**Technical Analysis and Findings**  
**Utah Coal Regulatory Program**

**PID:** C0410002  
**TaskID:** 4953  
**Mine Name:** SUFCO MINE  
**Title:** WASTE ROCK SITE EXPANSION

IF THIS MEASUREMENT DOES NOT MATCH WHAT IS SHOWN, THE SHEET SIZE HAS BEEN MODIFIED FROM: 11X17

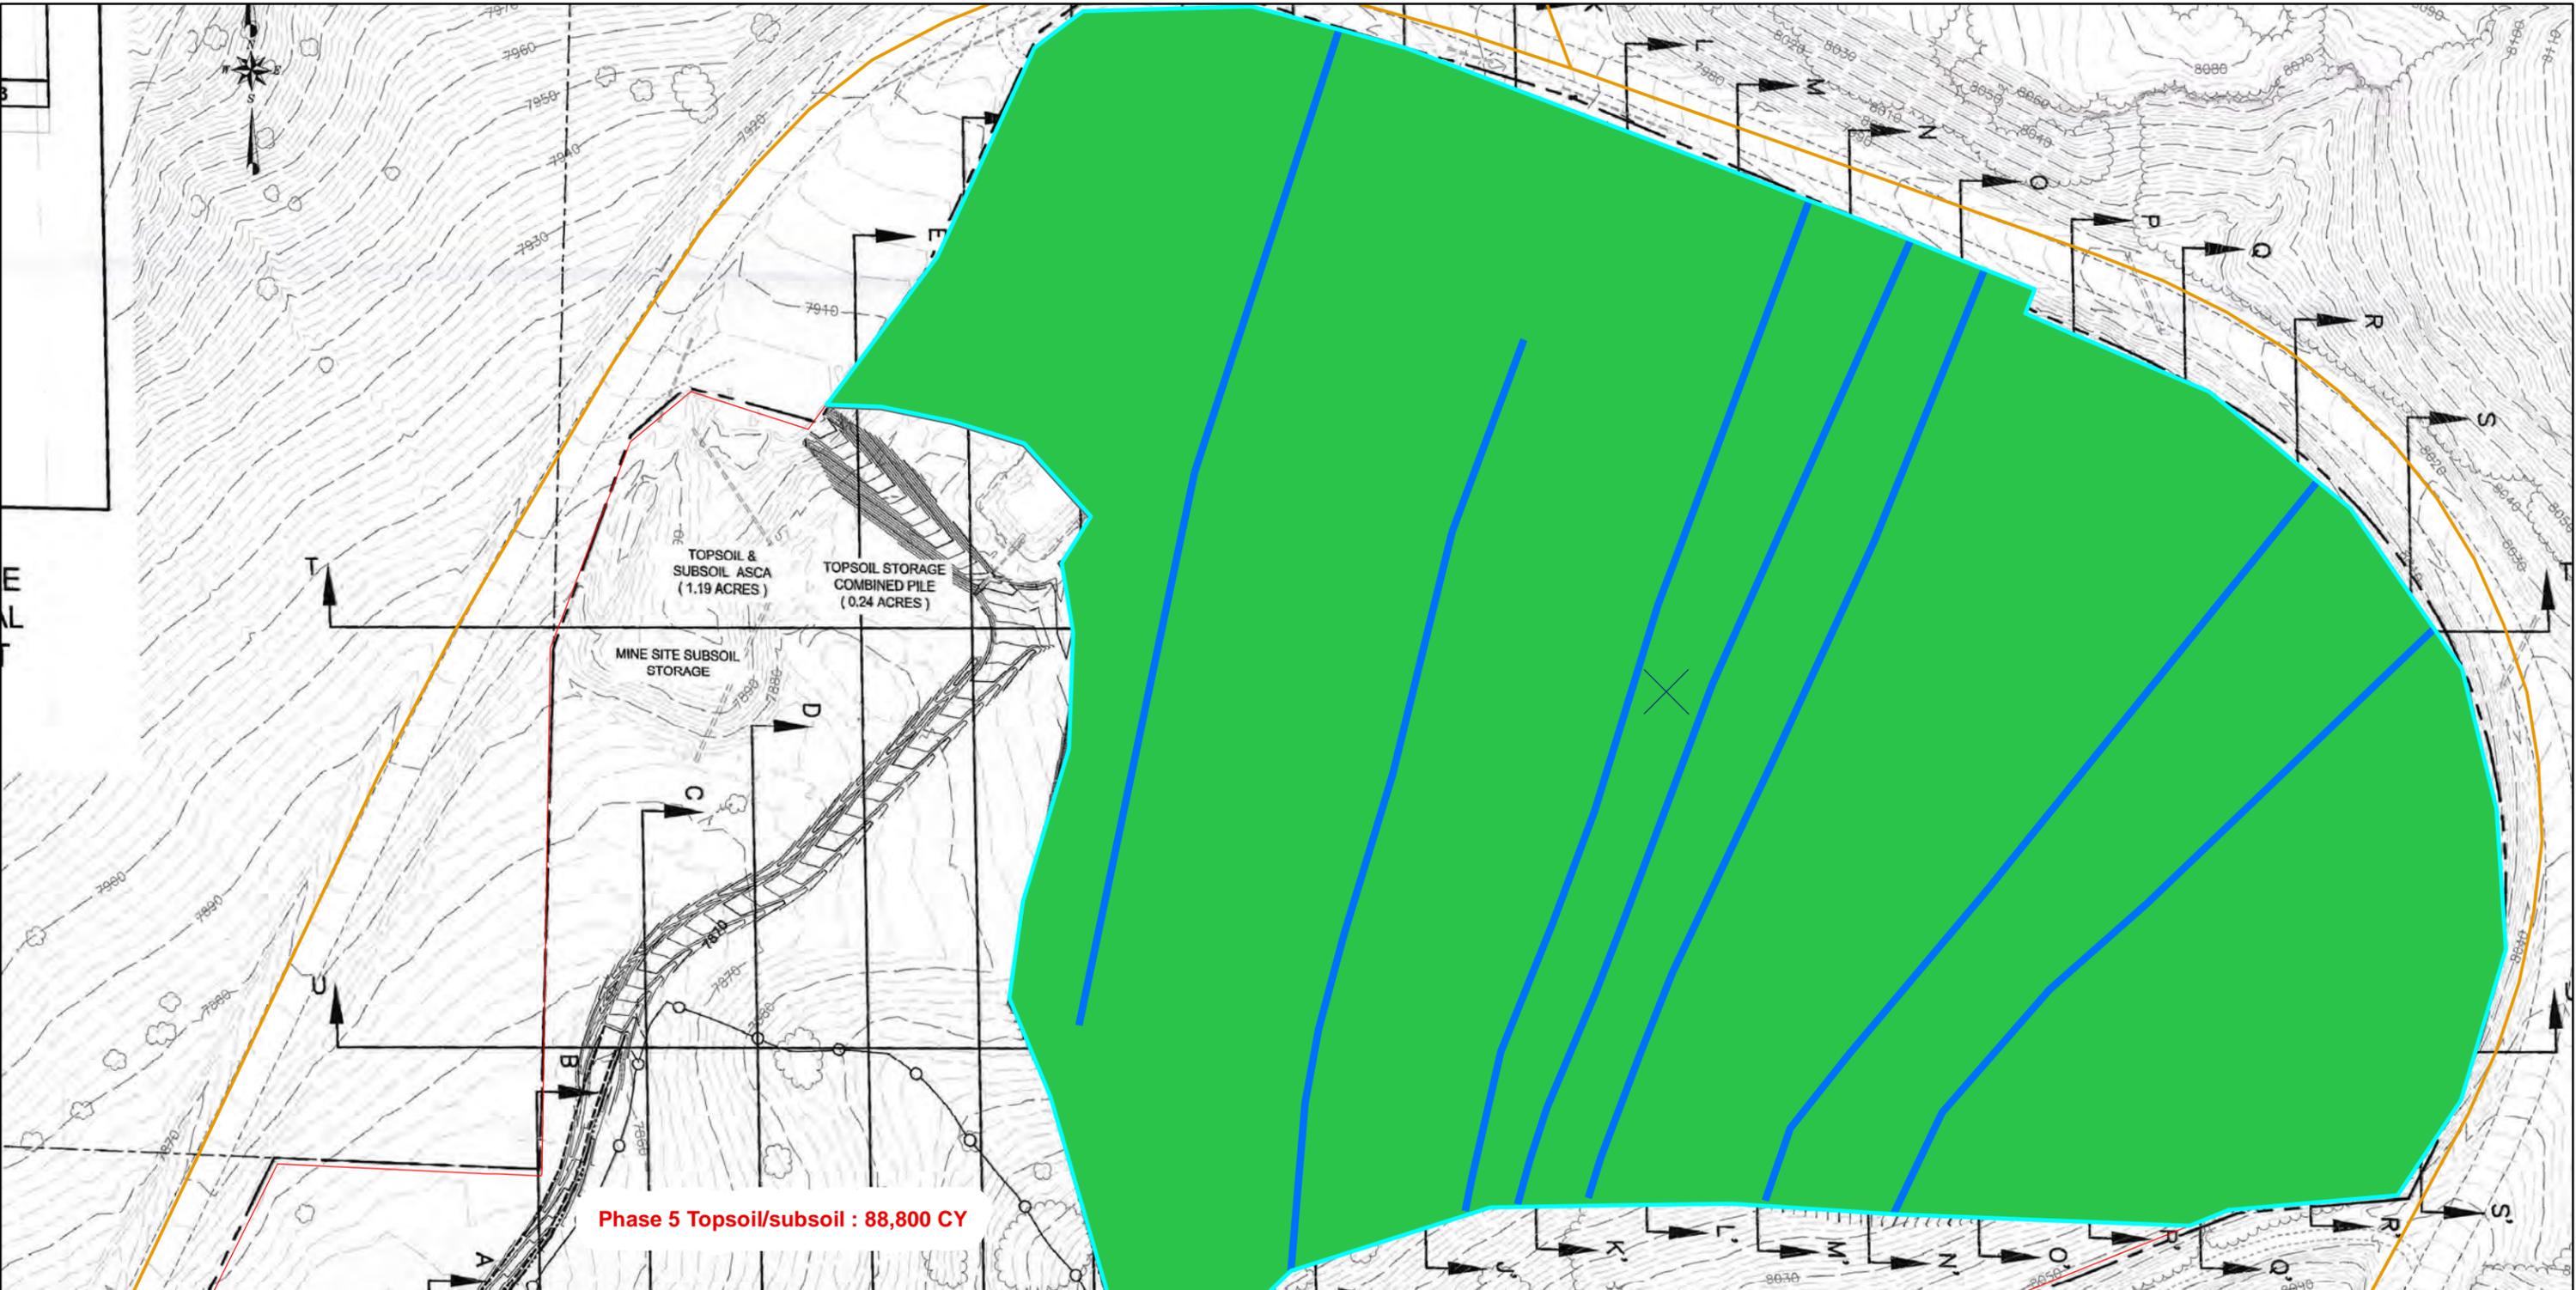
- The application does not detail how the various sequential phases of the waste rock pile will be tied into the existing waste rock pile in the narrative or on Maps 2A through 2E. Maps 2A through 2E, as shown, detail a channel between the existing and proposed waste rock piles as the topography abruptly ends before tying into the corresponding elevation on the existing waste rock pile. Based on the cross section detailed in Map 3A through 3C, the Division believes this is a simple error in the drawings representation of phase areas and the volumes shown on the maps account for the missing void shown on Maps 2A through 2E. The Permittee will amend Maps 2A through 2E to show the proposed operational map tying into existing contours on all sides, as shown on the condensed map on Figure 1 attached.

- Map 4A through 5E shows the approximate footprint area of each phase of the waste rock pile construction, however, they do not detail the area to be worked in the corresponding existing waste rock pile to tie the contours together to achieve a final surface as represented in Map 8. Maps 4A through 5E will be edited to show the complete footprint of where waste rock will be placed including in the proposed waste rock pile and over the existing waste rock pile. See Figure 1 for an approximation of contours.

• The application does not detail how the various sequential phases of the waste rock pile will be tied into the existing waste rock pile in the narrative or on Maps 2A through 2E. Maps 2A through 2E present confusing information as the maps do not show how the proposed waste rock pile will tie into the existing waste rock pile. Maps 2A through 2E, as shown, detail a channel between the existing and proposed waste rock piles as the topography abruptly ends before tying into the corresponding elevation on the existing waste rock pile. Based on the cross section detailed in Map 3A through 3C, the Division believes this is a simple error in the drawings representation of phase areas. The Permittee amend Maps 2A through 2E to show the proposed operational map key into existing contours on all sides.

• Map 4A through 5E shows the approximate footprint area of each phase of the waste rock pile construction, however, the maps do not detail the area to be worked in the corresponding existing waste rock pile to tie the contours together to achieve a final surface as represented in Map 8. Maps 4A through 5E will be edited to show the complete footprint of where waste rock will be placed including in the proposed waste rock pile and over the existing waste rock pile. See Figure 1 for an approximation of contours.
